Response to Request for Clarification
Contractor: PCA Engineering, Inc.

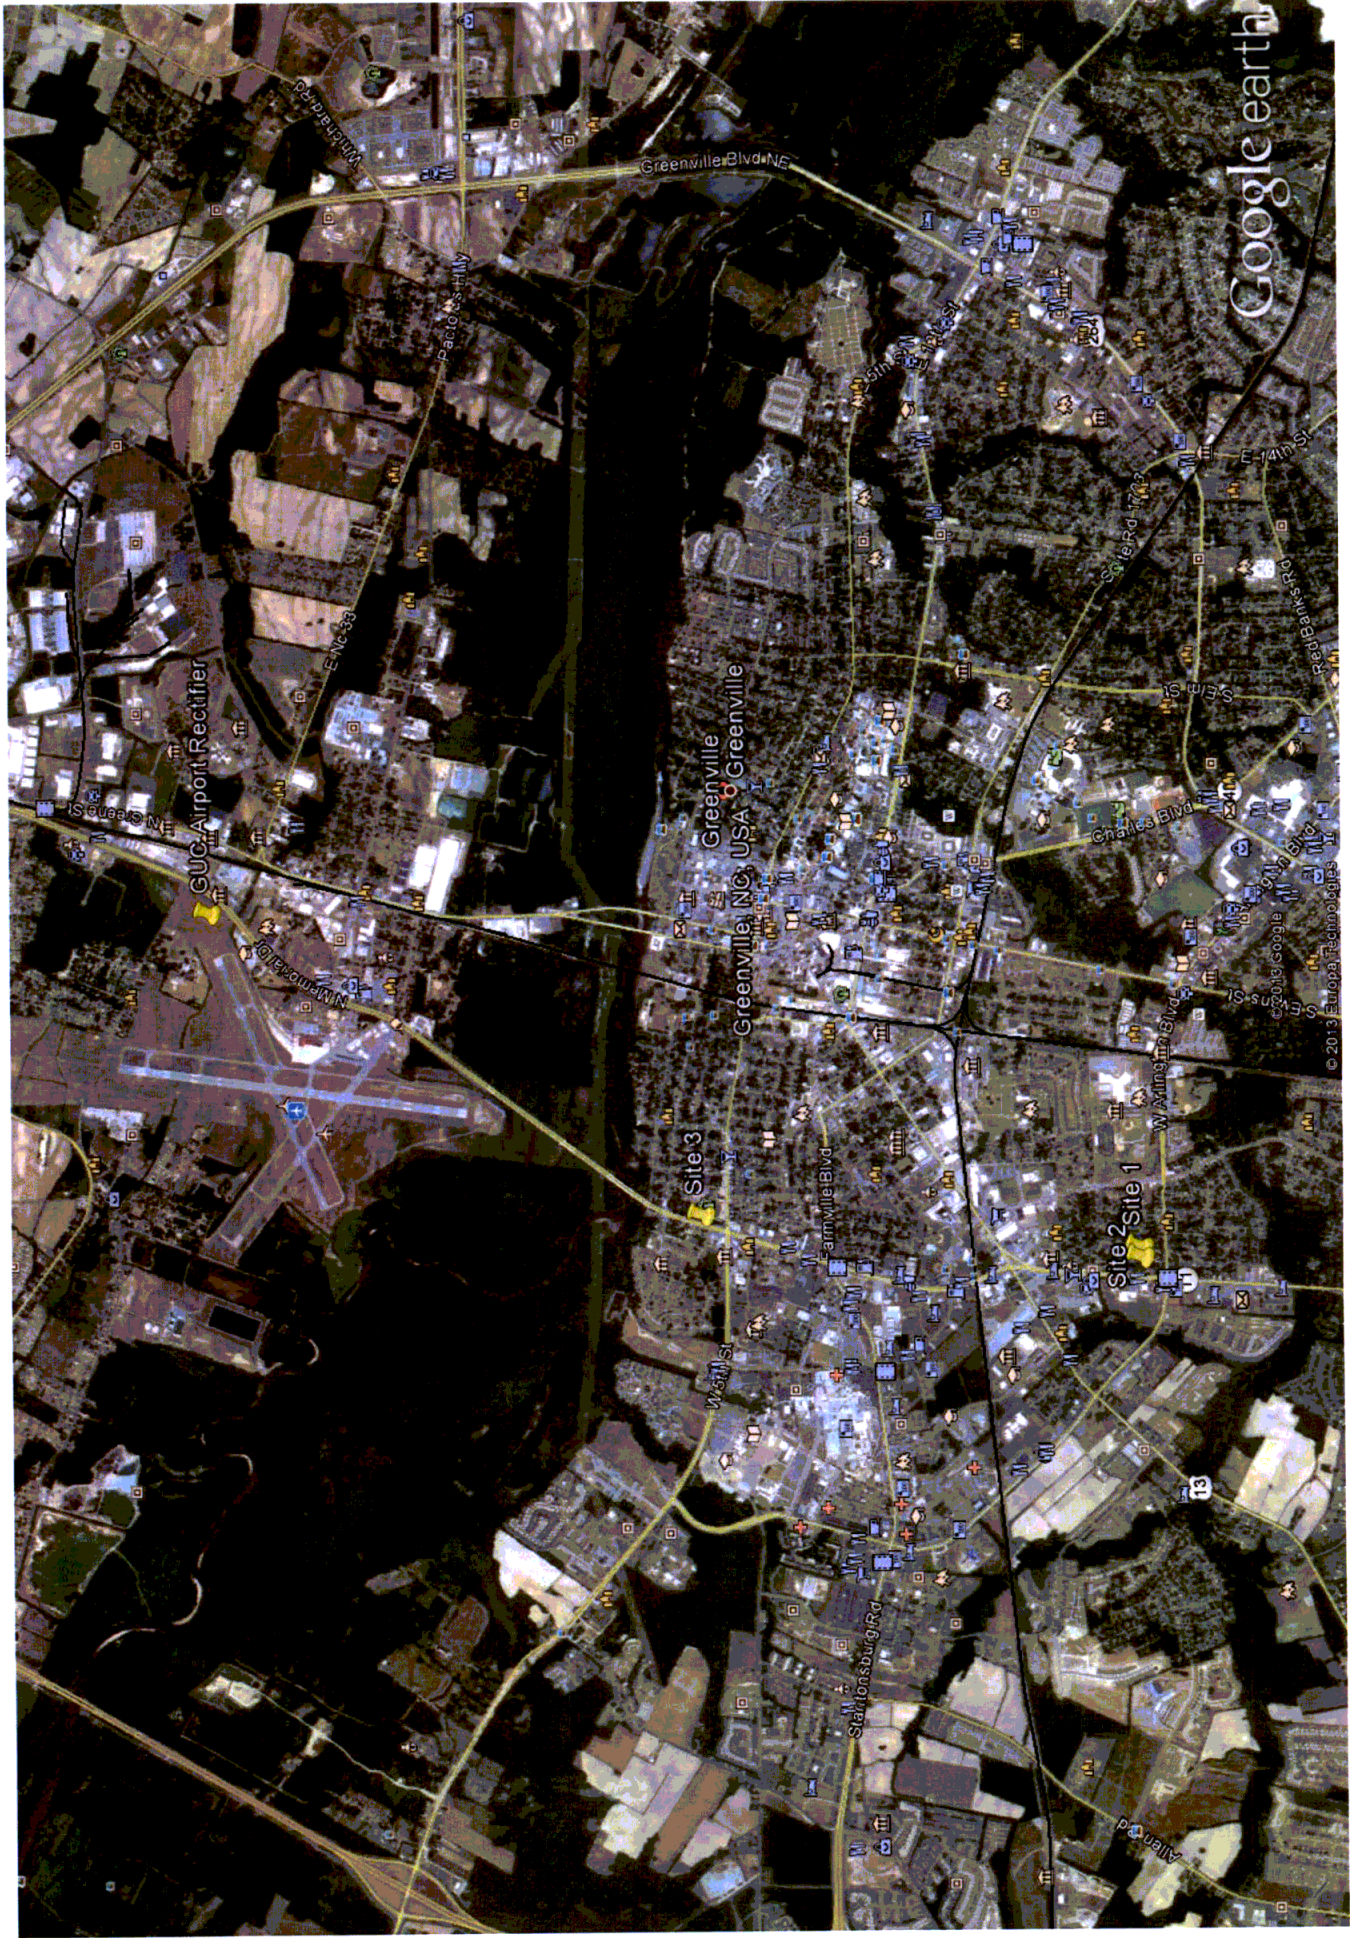
- **The map indicates there may be 3 pages, but only 2 pages are attached.**
The RFQ includes only two map pages (indicated as pages 14 and 15). Please disregard any other page references on the maps.
- **What is the location of the existing airport rectifier/groundbed in proximity to the 3 proposed new locations? What is the history and configuration of the existing airport rectifier system, i.e. does it provide complete protection to all the necessary piping? Is the existing system being abandoned or is this a supplement to the existing system?**
The airport rectifier is located approximately two (2) miles north of Site 3, on N. Memorial Drive (US Hwy 13/NC Hwy 11). Please see the attached vicinity map for reference, showing the three (3) potential rectifier locations and the existing Airport Rectifier location.

The Airport Rectifier provided cathodic protection to the steel gas main(s) that run near Memorial Drive in the area. It provided complete protection for this piping, and was recently abandoned. The rectifier proposed in the RFQ will replace the Airport Rectifier.
